Strategies for Monitoring the Performance of DNAPL Source Zone Remedies

August 2004

Prepared by
The Interstate Technology & Regulatory Council
Dense Nonaqueous-Phase Liquids Team

Figure 2-1. Conceptual Model of a DNAPL Source Within the Saturated Zone

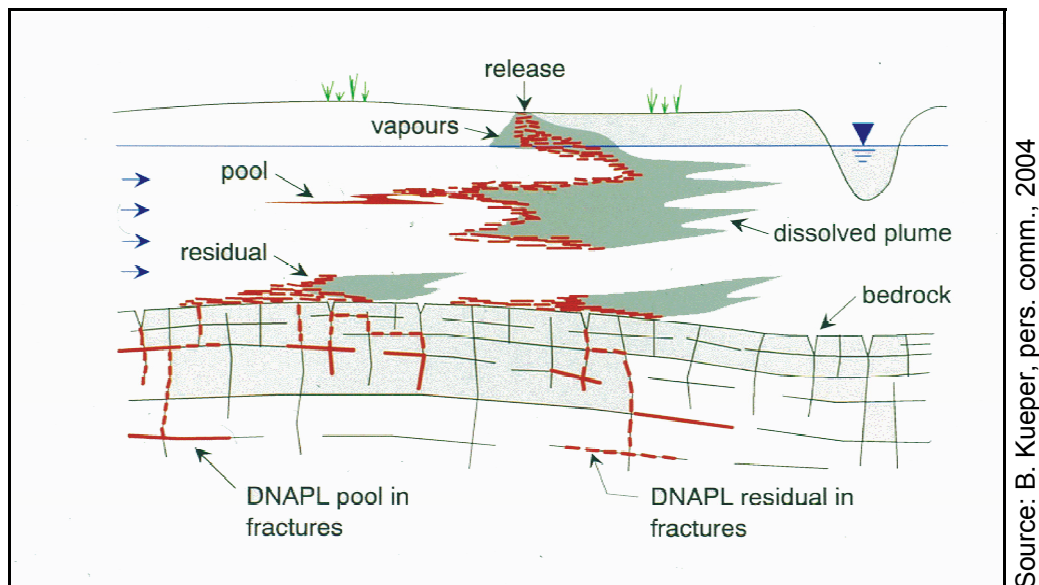
105. Figure 2-1, page 9: I am unable to differentiate between the two DNAPL zone/areas labeled "Pool" and "Residual" in the figure. If it's possible, please be sure that the labeled areas are not "questionable" areas that may fit both descriptions or if it may fit both, label it "Pool/Residual."

256. *On Figure 2-1 on Page 9, this figure should be modified to clearly illustrate the difference between residual and pooled DNAPL as defined in the text. The current illustration is unclear.*

Figure 4-1. Categories of Performance Metrics for DNAPL Zone Treatment

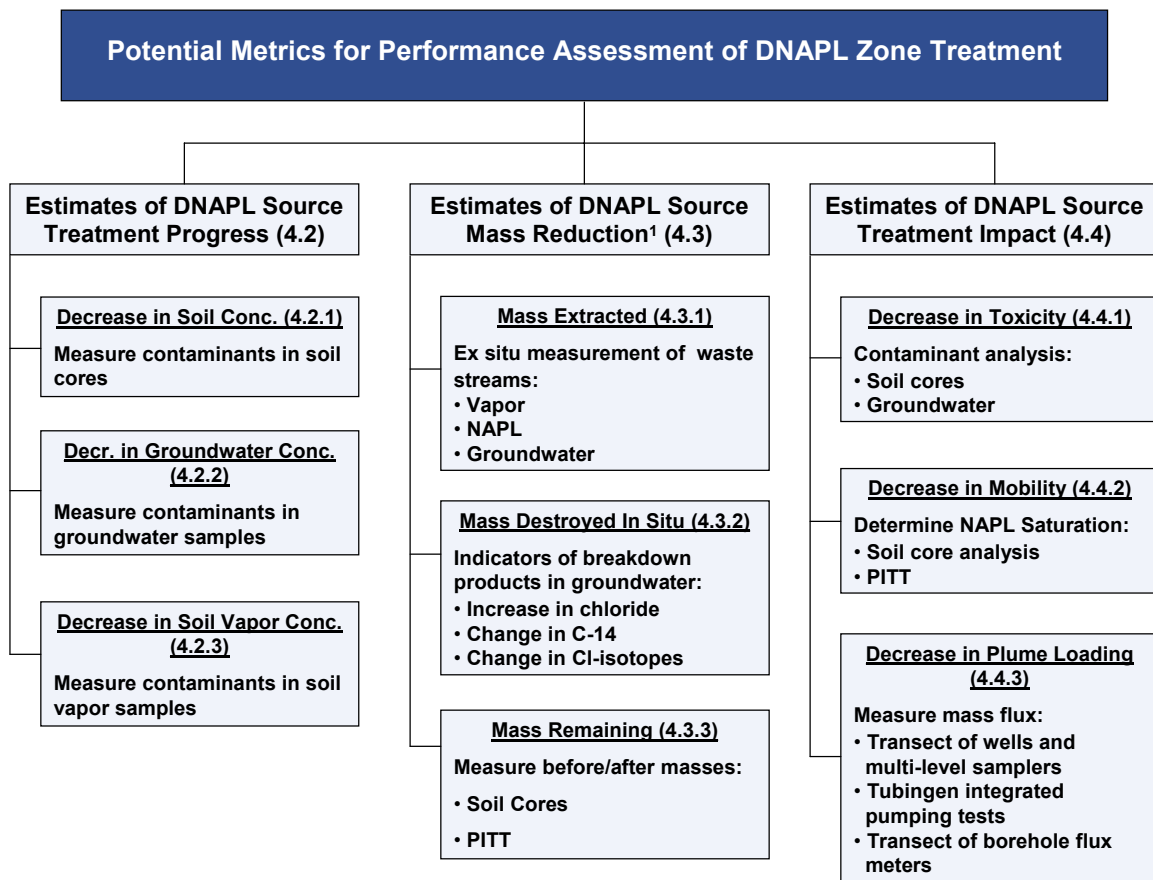
15. *Figure 4-1. Under “Decrease in Mobility” you might want to include reduced NAPL thickness in wells and reduced formation transmissivity to NAPL (e.g. bail down or low flow pumping tests)*

Figure 4-2. Concept of Mass Flux/Discharge and Source Strength

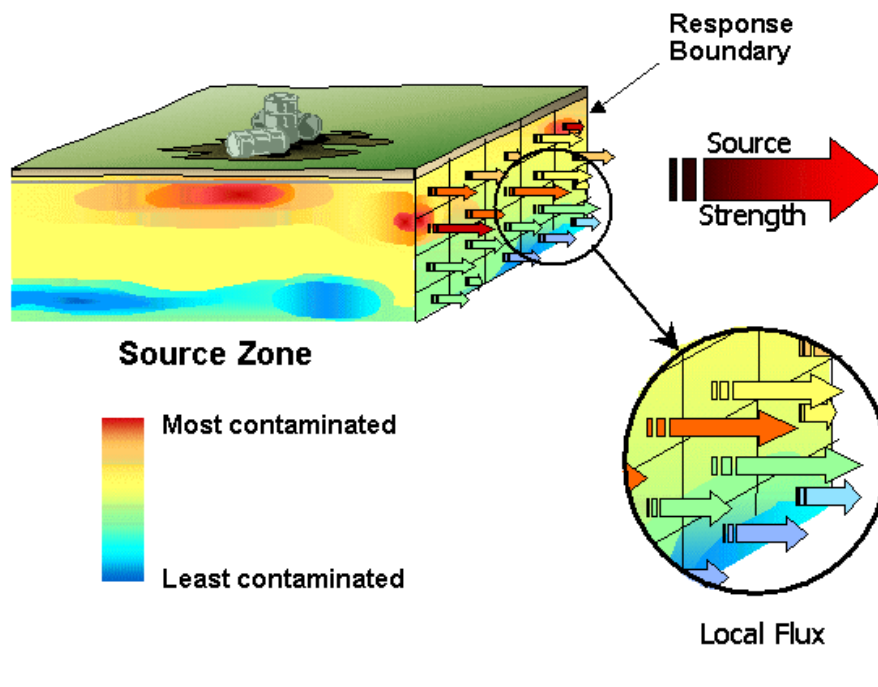
127. Figure 4-2, page 69: There are two large arrows with "Contaminant Flux (J)" -- there are two concerns: (1) it is difficult to determine if the symbol after the letter J is a comma or period or some other extraneous character and (2) the letter/variable "J" should be explained/introduced.

339. *Figure 4-2: Labels on large arrows should be changed from "Contaminant Flux" to "Contaminant Discharge".*

Figure B6-1. Kings Bay Phase I-III Results Showing Dissolved PCE Concentrations

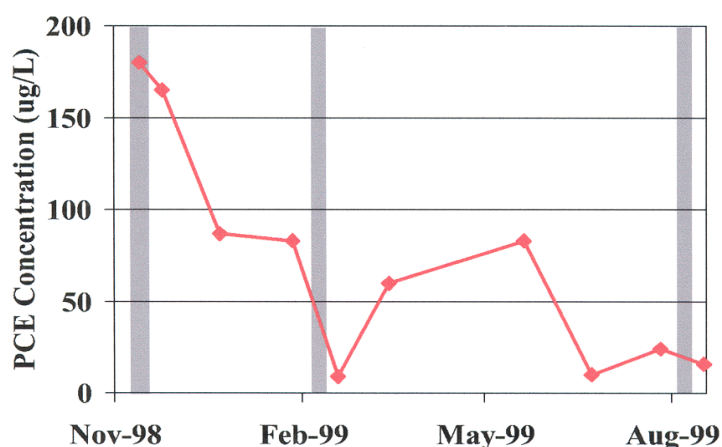
203. Case Study 6. This case study does not include any information about monitoring for temperature increases due to the high H₂O₂ concentrations used, nor about the vapor monitoring results. Pg. B-34, 3rd paragraph - The PCE concentration is given as 9,000 "Fg/l". The units need to be corrected. Figure 1 - This figure only provides concentration data to August 1999; however, additional site characterization, oxidant injection, and/or monitoring occurred through 2002. It is recommended that the figure be replaced by one that provides the complete history of the concentrations at the site.
